80960Jx Processor

Specification Update

December 1998

Order Number: 272852-006

Figure 6. 196-Ball Mini Plastic Ball Grid Array Top View - Balls Facing Down

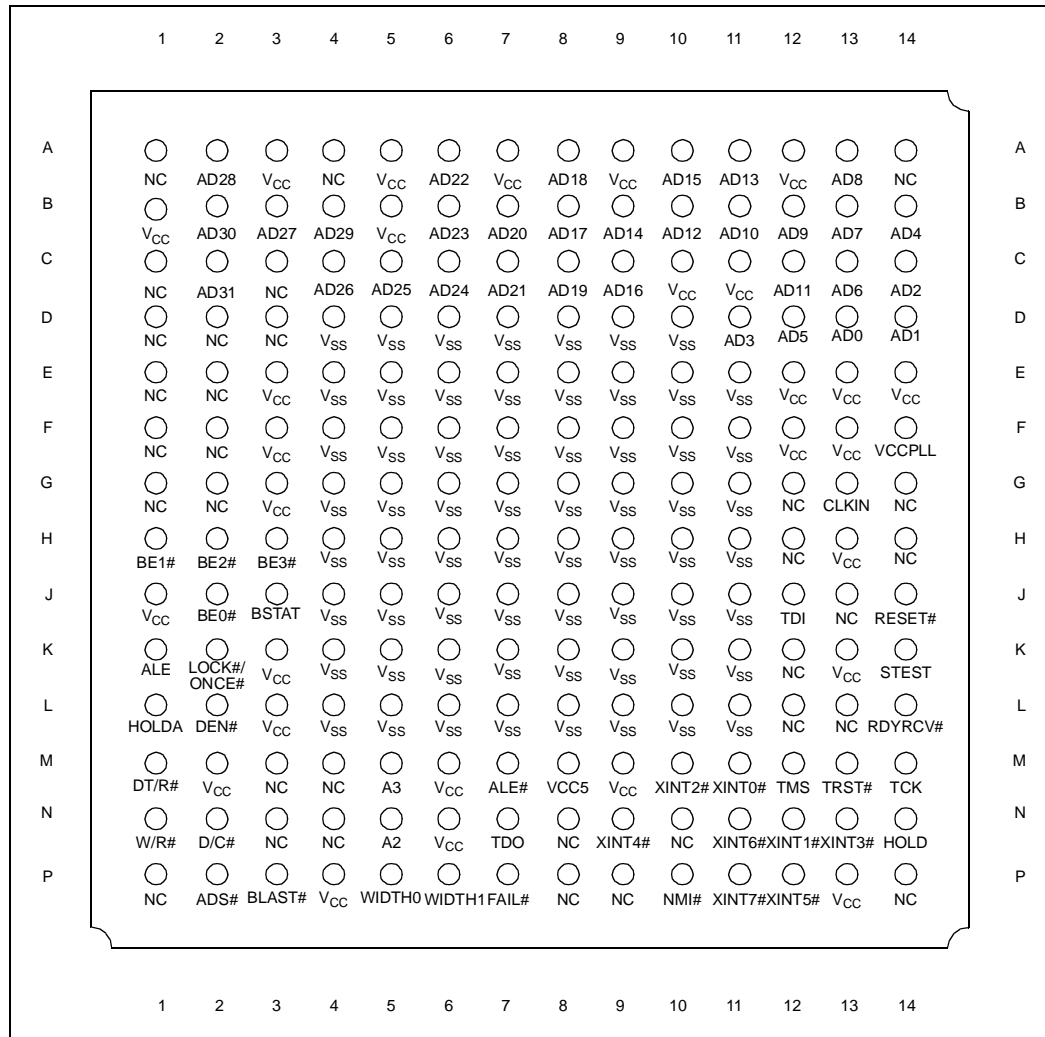
Problem: The two pinout diagrams for the 196-Ball MPBGA package (Figures 6 and 7 in both documents listed below) incorrectly show the orientation of the package. Also, the figure titles incorrectly indicate which is the top view and which is the bottom view and contain the wrong indication of “Balls Facing Up” and “Balls Facing Down.”

Figure 6 is the top view, “Balls Facing Down,” and should be oriented as shown:

Output Delay or Hold vs. Load Capacitance (3.3 V Signals)

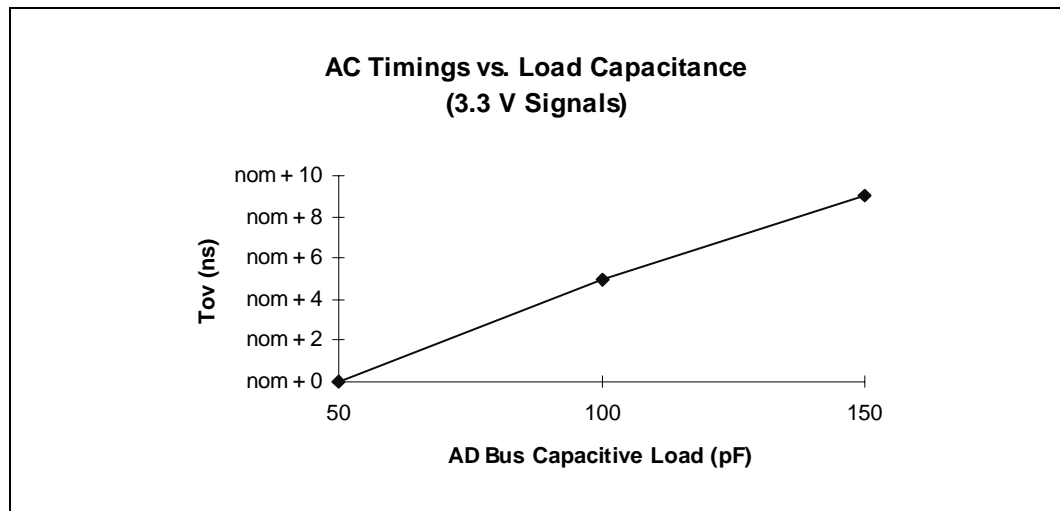
Problem: *80960JA/JF/JD/JT 3.3 V Microprocessor* datasheet, the “Output Delay vs. Load Capacitance” diagram and the “TLX vs. AD Bus Load Capacitance” diagrams do not apply to the 80960JT microprocessor (they are correct, however, for the JA/JF/JD microprocessors). The following diagrams and related notes provide the correct derating curve information for the 80960JT microprocessor:
